MY00 FINAL MONITORING REPORT

**Dales Creek Restoration Site
Buncombe County, North Carolina
French Broad River Basin - 06010105**

MEMORANDUM

Date: September 1, 2022
To: Harry Tsomides, DMS Project Manager
From: Adam Spiller, Project Manager
KCI Associates of North Carolina, PA
Subject: MY-00 Monitoring Report Comments
Dales Creek DMS #7910, Contract 100128
French Broad River Basin CU 06010105
Buncombe County, North Carolina

CURRENT CONDITIONS PLAN VIEW
DALES CREEK RESTORATION SITE
BUNCOMBE COUNTY, NC

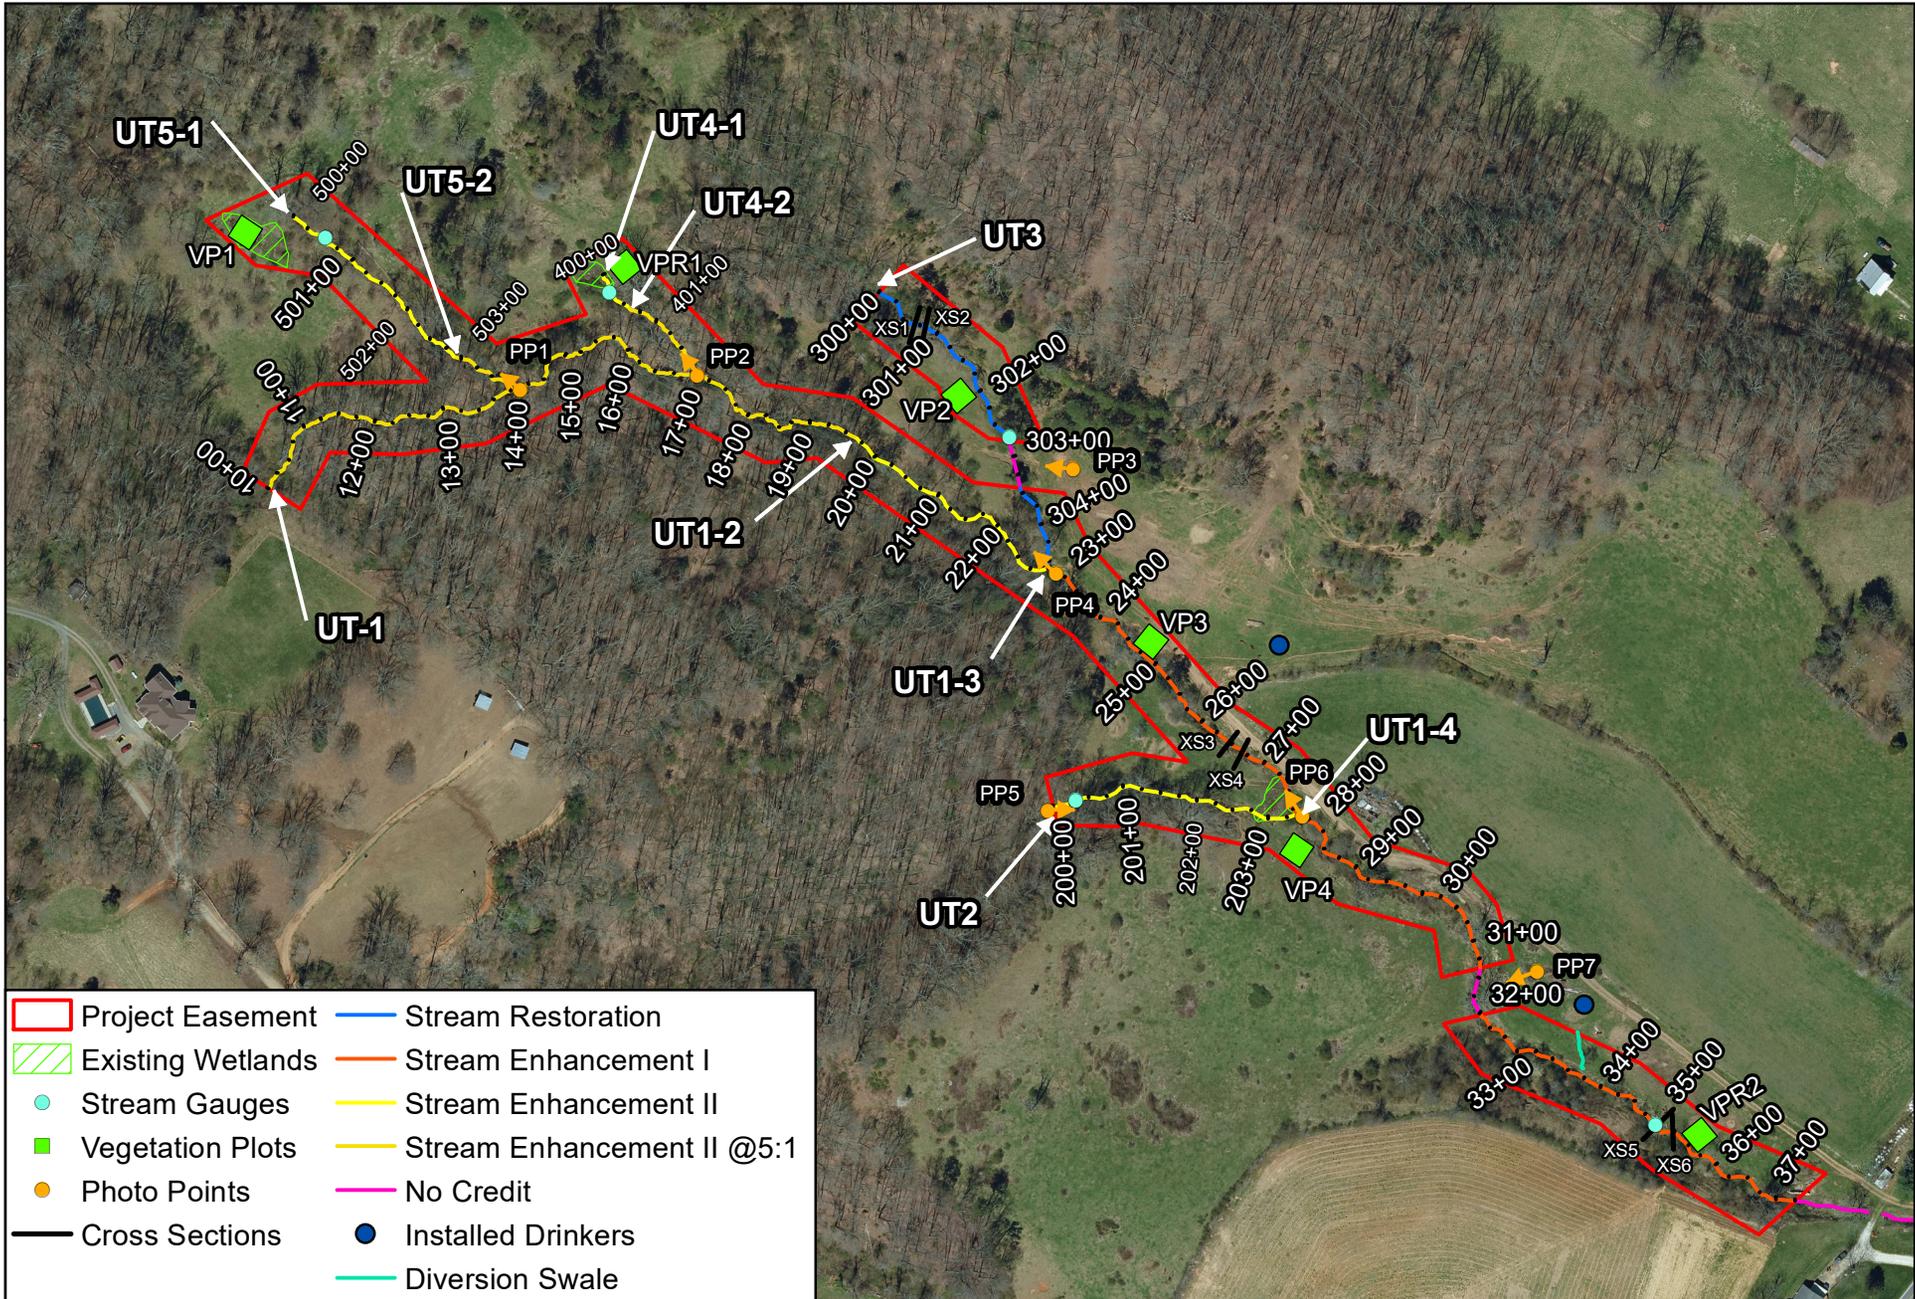
2. A PLS-sealed as built survey is needed for the project.
KCI Response: This has been provided with the final deliverables.
3. Crossing area fencing was not accurately depicted on the as built. Please include the installed fence layer and existing fence layer on the CCPV, as built survey, and record drawings. The installed fence should be a surveyed layer to verify correct placement. Any fencing or features no longer present should not appear on the as built survey.
KCI Response: The surveyed fence layer has been provided with the final deliverables.

6. Any hydrologic features for example the wet /grassy swales that was installed to accommodate floodplain drainage from the concrete ring waterer. The waterers should be shown in the survey as well. Please include these features on the as-built, CCPV and include a feature shape file in the digital deliverable.
KCI Response: These features have been included in both the as-built and CCPV.
